GRID CODE MODIFICATION GC0148

LEGAL TEXT – STORAGE

RELEVANT GRID CODE EXTRACTS

18 MARCH 2022

Figure ECC.6.3.3(a) **Active Power** Output with falling frequency for **Power Generating Modules** and **HVDC Systems** and **Electricity Storage Modules** when operating in an exporting mode of operation

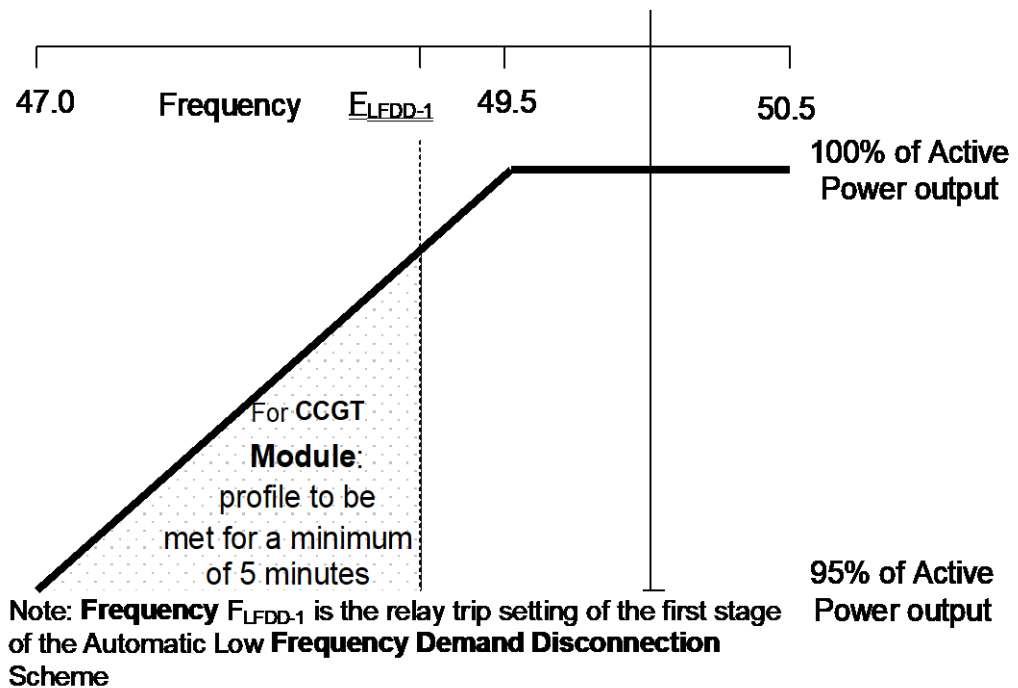
- (a) continuously maintaining constant **Active Power** output for **System Frequency** changes within the range 50.5 to 49.5 Hz; and
- (b) (subject to the provisions of ECC.6.1.2) maintaining its **Active Power** output at a level not lower than the figure determined by the linear relationship shown in Figure ECC.6.3.3(a) for **System Frequency** changes within the range 49.5 to 47 Hz for all ambient temperatures up to and including 25°C, such that if the **System Frequency** drops to 47 Hz the **Active Power** output does not decrease by more than 5%. In the case of a **CCGT Module**, the above requirement shall be retained down to the **Low Frequency Relay** trip setting of 48.8 Hz, which reflects the first stage of the Automatic Low **Frequency Demand Disconnection** scheme notified to **Network Operators** under OC6.6.2. For **System Frequency** below that setting, the existing requirement shall be retained for a minimum period of 5 minutes while **System Frequency** remains below that setting, and special measure(s) that may be required to meet this requirement shall be kept in service during this period. After that 5 minutes period, if **System Frequency** remains below that setting, the special measure(s) must be discontinued if there is a materially increased risk of the **Gas Turbine** tripping. The need for special measure(s) is linked to the inherent **Gas Turbine Active Power** output reduction caused by reduced shaft speed due to falling **System Frequency**. Where the need for special measures is identified in order to maintain output in line with the level identified in Figure ECC.6.3.3(a) these measures should be still continued at ambient temperatures above 25°C maintaining as much of the **Active Power** achievable within the capability of the plant. For the avoidance of doubt, **Generators** in respect of **Pumped Storage Plant** and **Electricity Storage Modules** shall also be required to satisfy the requirements of OC6.6.6.

Figure ECC.6.3.7.2.3(a) **Active Power** performance with falling frequency

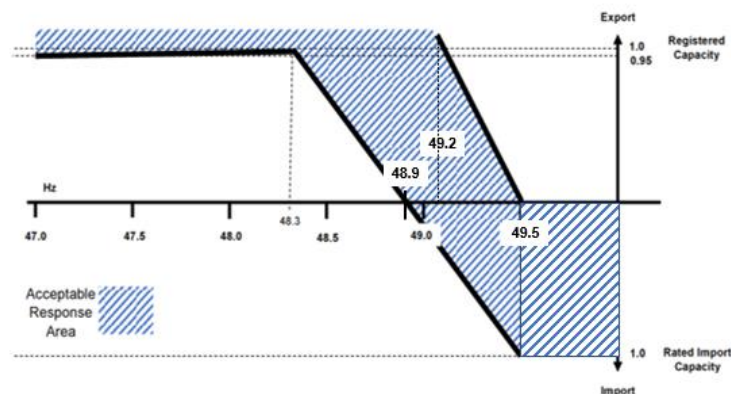
- (a) Be capable of automatically maintaining its **Active Power** output within the shaded operating region shown in Figure ECC.6.3.7.2.3(a) until the stored energy has been depleted, except in the case where the **Black Start Service Provider** or **Restoration Service Provider** has a **Black Start Contract** or **Restoration Service Contract** in which case the stored energy shall not be depleted below the level required to meet the contractual obligations of a **Black Start Contract** or a **Distribution Restoration Contract**. The **Electricity Storage Module** could initially be operating at any import between zero **Active Power** and the **Maximum Import Power** within a **System Frequency** range of 50Hz and 49.5Hz as shown in Figure ECC.6.3.7.2.3(a). For the avoidance of doubt, the **Electricity Storage Module** would only be required to reach its **Maximum Capacity** if the **Electricity Storage Module** has headroom and the ability to increase **Active Power** output. A typical value of the **Droop** would be 0.6% where this does not result in control system instability or plant difficulties. In all cases the **Droop** shall be between 0.6% and 1.2% and shall be agreed with **The Company**.

- (b) Automatically respond in accordance with the characteristic of Figure ECC.6.3.7.2.3(a) when the **System Frequency** falls to 49.5Hz and below.

- (c) The reduction in **Active Power** import (during an import mode of operation), and the transition to the final value of **Active Power** output shall be continuously and linearly proportional, as far as is practicable, to the reduction in **Frequency** below 49.5 Hz. **Active Power** output must be provided increasingly with time as required by (d) below.

- (d) As much as possible of the proportional reduction in **Active Power** import (when the **Electricity Storage Module** is in a mode analogous to **Demand**) must result from the **Frequency** control device (or speed governor) action and must be achieved within 10 seconds of the time of the **Frequency** decreases below 49.5 Hz. The **Electricity Storage Module** shall be capable of initiating a power **Frequency** response with an initial delay that is as short as possible. Delays that exceed 2 seconds shall be justified by the **Generator** or **Defence Service Provider** or **Restoration Service Provider** or **Non-Embedded Customer** providing technical evidence to **The Company** and in any event as much as possible of the proportional reduction in **Active Power** import shall be achieved within 10 seconds. This performance requirement is to be maintained when the **Electricity Storage Module** makes the transition to an **Active Power** export mode of operation unless the energy store is depleted, in which case it shall be required to operate at zero **Active Power** output.

- (e) Where the **Electricity Storage Module** is not capable of making a transition from import operation to export operation within 20 seconds of the **System Frequency** falling to 49.2Hz, then it shall then immediately reduce its **Active Power** import to zero.

- (f) If the **Electricity Storage Module** has not achieved at least a zero **Active Power** import when the **System Frequency** has reached 48.9Hz, it shall be instantaneously tripped. Where a **Electricity Storage Module** trips, it shall not be permitted to reconnect to the **System** until instructed by **The Company** in accordance with BC2.5.2 and as provided for in ECC.6.2.2.11.

Figure ECC.6.3.7.2.3(b) **Active Power** performance with increasing frequency

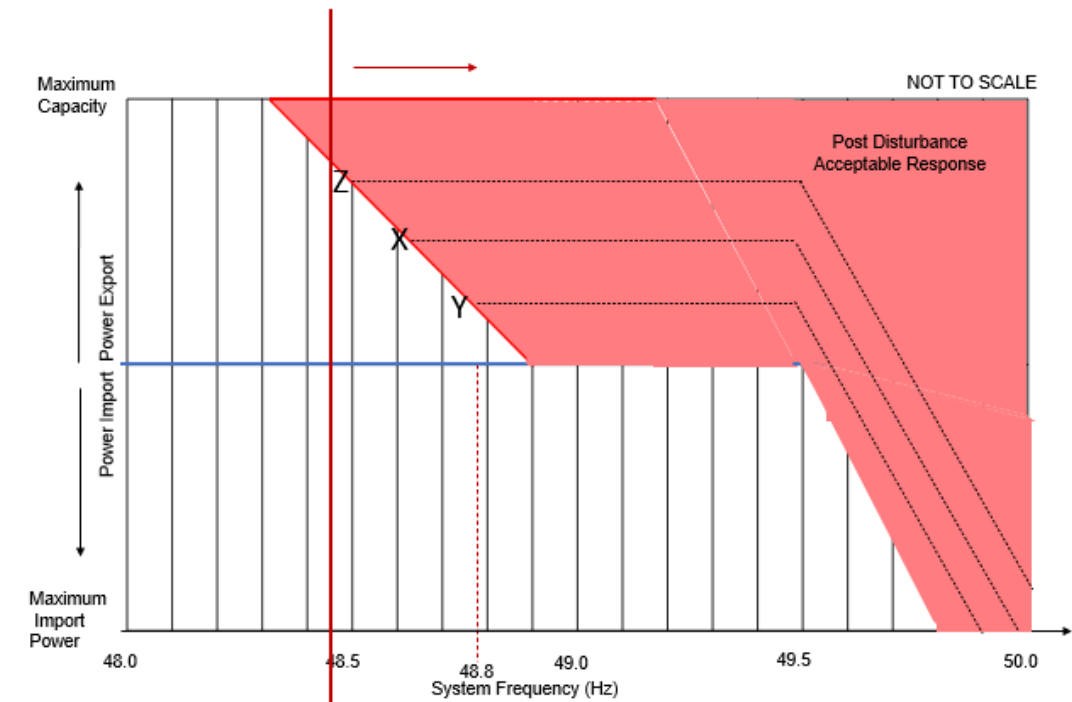
ECC.6.3.7.2.3.2 Where an **Electricity Storage Module** has been importing and has responded in accordance with the requirements of ECC.6.3.7.2.3.1, its performance, once the **System Frequency** starts to rise above the minimum reached, shall be in accordance with Figure ECC.6.3.7.2.3(b) in respect of the **Active Power** output and **Active Power** import. For example, Figure ECC.6.3.7.2.3(b), illustrates the three points X, Y and Z. If points X, Y and Z denotes the minimum frequency that the **Total System** reached during a particular low **System Frequency** event, as the **System Frequency** starts to rise, the **Active Power** output of the **Electricity Storage Module** should remain at a constant level (where the energy source has not been depleted) until 49.5Hz is reached as denoted by the dashed black lines. Once the **System Frequency** has risen above 49.5Hz the **Electricity Storage Module** is permitted to reduce **Active Power** output so long as it is operates within the shaded area above 49.5Hz shown in Figure ECC.6.3.7.2.3(b), unless the **Electricity Storage Module** has insufficient capability in which case it shall operate at zero **Active Power**

Figure ECP.A.3.6.4

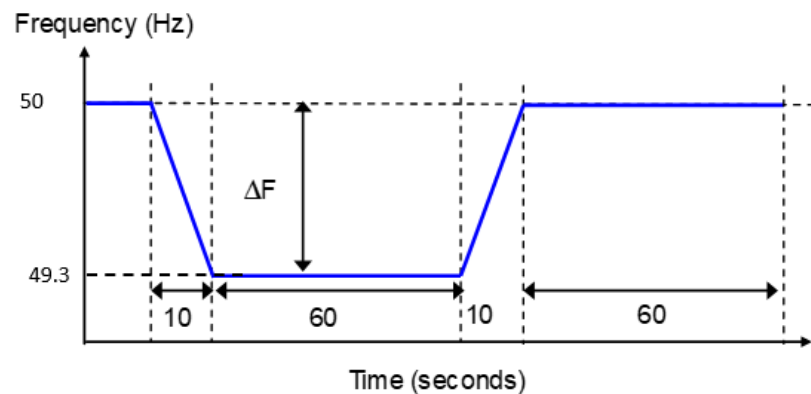
ECP.A.3.6.11 For **Generators** in respect of **Electricity Storage Modules** who have agreed with **The Company** to satisfy the **Droop** requirements of ECC.6.3.7.2.3, the **Generator** shall submit simulation studies representing the response of the **Electricity Storage Module**. The simulation studies shall comprise:-

- (i) Initial conditions where the **Electricity Storage Module** shall be operating at its **Maximum Import Power** with the **Electricity Storage Module** in **Limited Frequency Sensitive Mode**.

- (ii) A simulation signal shall be applied which ramps the **System Frequency** from 50Hz to 49.3Hz over 10s. The **System Frequency** shall be held at 49.3Hz for 60s and the then ramped back to 50Hz in 10s as shown in Figure ECP.3.6.4.

- (iii) The simulated results should show a reduction in **Active Power** in accordance with the requirement of ECC.6.3.7.2.3.1. When the test injection signal is held at 49.3Hz, the **Active Power** output of the **Electricity Storage Module** should achieve a steady state operating point in no more than 10s and this should be maintained whilst the test frequency signal is held at 49.3Hz.

- (iv) A simulation signal is then ramped from 49.3 Hz to 50Hz over a 10s period. The **Electricity Storage Module** should return back to its **Maximum Import Power** at 49.5Hz in line with the performance requirements of ECC.6.3.7.2.3.1.

- (v) The above test shall be repeated with the **Electricity Storage Module** operating at 50% of its **Maximum Import Power**.

Figure ECP.A.3.6.5

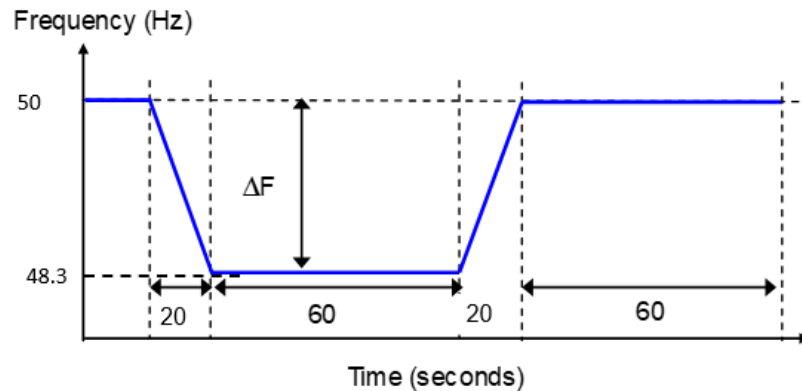
ECP.A.3.6.12 In addition to the requirements of ECP.A.3.6.11 a set of simulation studies shall be submitted to demonstrate the performance of the **Electricity Storage Module** during extreme **Frequency** conditions. The simulated studies shall comprise:-

- (i) Initial conditions where the **Electricity Storage Module** shall be operating at its **Maximum Import Power** with the **Electricity Storage Module** in **Limited Frequency Sensitive Mode**.

- (ii) A simulation signal which ramps the **System Frequency** from 50Hz to 48.3Hz over 20s. The **System Frequency** shall be held at 48.3Hz for 60s and the then ramped back to 50Hz in 20s as shown in Figure ECP.3.6.5.

- (iii) The simulation shall demonstrate of the ability of the **Electricity Storage Module** to reach its **Maximum Capacity** (or otherwise) in accordance with the requirements of ECC.6.3.7.2.3. When the test injection signal is held at 48.3Hz, the **Active Power** output of the **Electricity Storage Module** should achieve a steady state operating point in no more than 10s and this should be maintained whilst the test frequency signal is held at 48.3Hz.

- (iv) An applied simulated signal which ramps from 48.3 Hz to 50Hz over a 20s period. The **Electricity Storage Module** should return back to its **Maximum Import Power** at 49.5Hz in line with the performance requirements of ECC.6.3.7.2.3.

The above test shall be repeated with the **Electricity Storage Module** is operating at 50% of its **Maximum Import Power**.

Figure 4

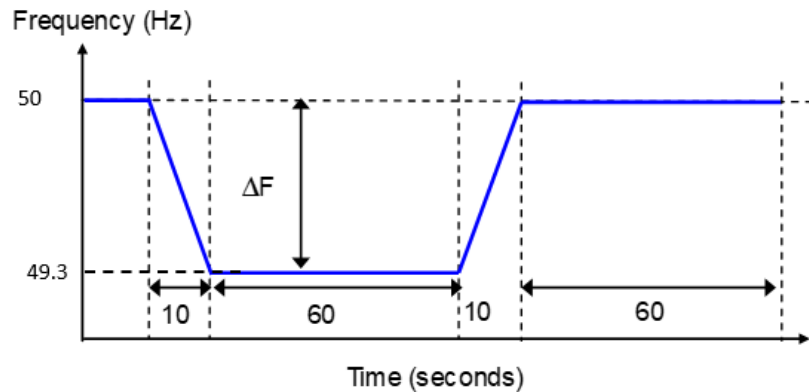
#### ECP.A.5.10 Compliance of **Synchronous Electricity Storage Modules** during low **System Frequencies**

- (i) Prior to the test, the **Synchronous Electricity Storage Module** shall be operating at its **Maximum Import Power** with the **Synchronous Electricity Storage Module** in **Limited Frequency Sensitive Mode**.

- (ii) A test signal shall be applied which ramps the **System Frequency** from 50Hz to 49.3Hz over 10s. The **System Frequency** shall be held at 49.3Hz for 60s and then ramped back to 50Hz in 10s as shown in Figure 4.

- (iii) The test result shall demonstrate a reduction in **Active Power** in accordance with the requirement of ECC.6.3.7.2.3. When the test injection signal is held at 49.3Hz, the **Active Power** output of the **Synchronous Electricity Storage Module** should achieve a steady state operating point in no more than 10 seconds and this should be maintained whilst the test **Frequency** signal is held at 49.3Hz.

- (iv) A test signal shall be ramped from 49.3Hz to 50Hz over a 10s period. The **Synchronous Electricity Storage Module** should return back to its **Maximum Import Power** at 49.5Hz in line with the performance requirements of ECC.6.3.7.2.3.

- (v) The above test shall be repeated with the **Synchronous Electricity Storage Module** is operating at 50% of its **Maximum Import Power**.

Figure 4

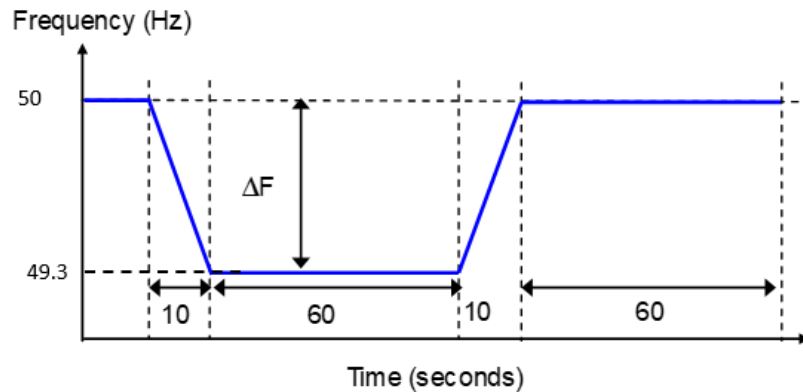
#### ECP.A.6.6.10 Compliance of **Non-Synchronous Electricity Storage Modules** during low **System Frequencies**

- (i) Prior to the test, the **Non-Synchronous Electricity Storage Module** shall be operating at its **Maximum Import Power** with the **Non-Synchronous Electricity Storage Module** in **Limited Frequency Sensitive Mode**.

- (ii) A test signal shall be applied which ramps the **System Frequency** from 50Hz to 49.3Hz over 10s. The **System Frequency** shall be held at 49.3Hz for 60s and then ramped back to 50Hz in 10s as shown in Figure 4.

- (iii) The test result shall demonstrate a reduction in **Active Power** in accordance with the requirement of ECC.6.3.7.2.3. When the test injection signal is held at 49.3Hz, the **Active Power** output of the **Non-Synchronous Electricity Storage Module** should achieve a steady state operating point in no more than 10 seconds and this should be maintained whilst the test **Frequency** signal is held at 49.3Hz.

- (iv) A test signal shall be ramped from 49.3 Hz to 50Hz over a 10 second period. The **Non-Synchronous Electricity Storage Module** should return back to its **Maximum Import Power** at 49.5Hz in line with the performance requirements of ECC.6.3.7.2.3.

- (v) The above test shall be repeated with the **Non-Synchronous Electricity Storage Module** is operating at 50% of its **Maximum Import Power**.
